CFe/TW  
10051  
28 September 2016

**SECTION 96(2) MODIFICATION APPLICATION TO SSD 5897  
BARANGAROO SOUTH STAGE 1B TEMPORARY STORMWATER DIVERSION WORKS**

**Figure 1** – Approved temporary stormwater diversion (SSD 5897)

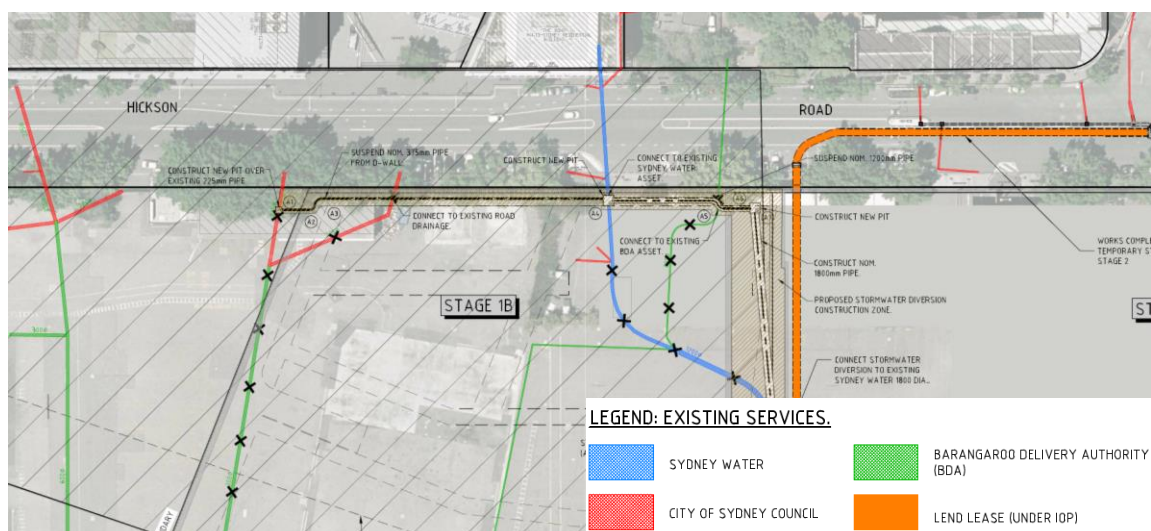
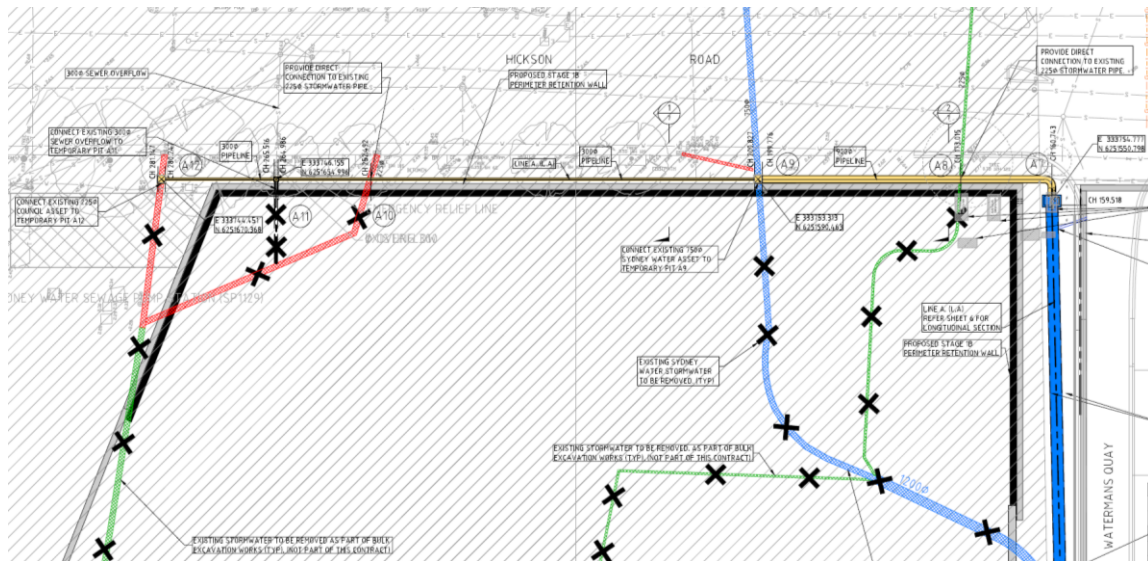
The subject of the modification is the position of the temporary stormwater pipe and pit arrangement. Under the layout currently approved as part of SSD 5897, the temporary stormwater pipe is designed to be fixed to the inside of basement perimeter wall associated with the construction of the Stage 1B Basement (SSD 6960). The proposed modification seeks approval for a second temporary option, which is to locate the temporary stormwater diversion pipe in the footpath on the western side of Hickson Road (i.e. just outside the Block 4 boundary).

**Figure 1** illustrates the temporary stormwater diversion solution as approved by SSD 5897. **Figure 2** illustrates the proposed second option.

To facilitate this diversion, SSD 5897 approved a temporary north-south pipe which would be located on the eastern boundary of Block 4, within the Stage 1B basement area. However, to ensure the efficient and timely delivery of the construction of the basement (proposed under SSD 6960) and to ensure the most safe and cost effective solution to temporary stormwater diversion works is available during construction, approval is now sought for a second option, to locate the temporary stormwater diversion pipe in the footpath on the western side of Hickson Road (i.e. just outside the Block 4 boundary). This application seeks the ability to retain both temporary stormwater diversion solutions as an option during construction.

The reason for the second option being sought is that the timing/staging of construction will dictate which option is selected. The timing of works will take into consideration proposed timing of bulk excavation works on Block 4 and adjacent remediation works in Hickson Road. Inclusion of the second option, the subject of this modification application, is proposed to allow flexibility for the selection of a temporary location, depending on final timing/staging of construction works.

Figure 3 – Proposed modified plan BB2\_PA1\_AA08 (Revision B, 19/9/2016)

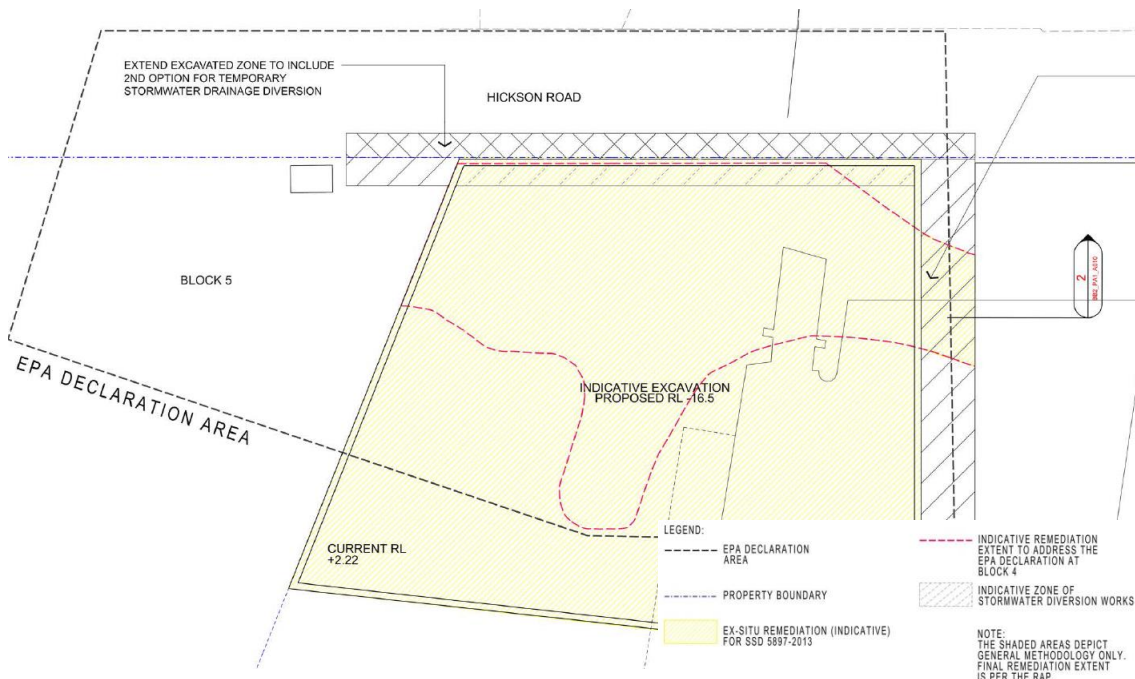
**Figure 3** below provides an extract of the modified plan BB2\_PA1\_A008 (Revision B, 19/9/2016)) which seeks to extend the indicative zone of stormwater diversion works to within the area required for the stormwater diversion works associated with the proposed Option 2 (refer to **Appendix A**).

**Reason for modification:** This condition is updated to permit the second temporary stormwater diversion option whilst retaining the current temporary solution approved with SSD 5897. Drawing BB2 PA1 A008 has been amended to extend the indicative zone of stormwater works which will accommodate the works required under both options. The detail of both temporary stormwater diversion options is retained through reference to the original EIS, Response to Submissions Report and associated appendices and the information in the supporting appendices of this Section 96(2) modification application.
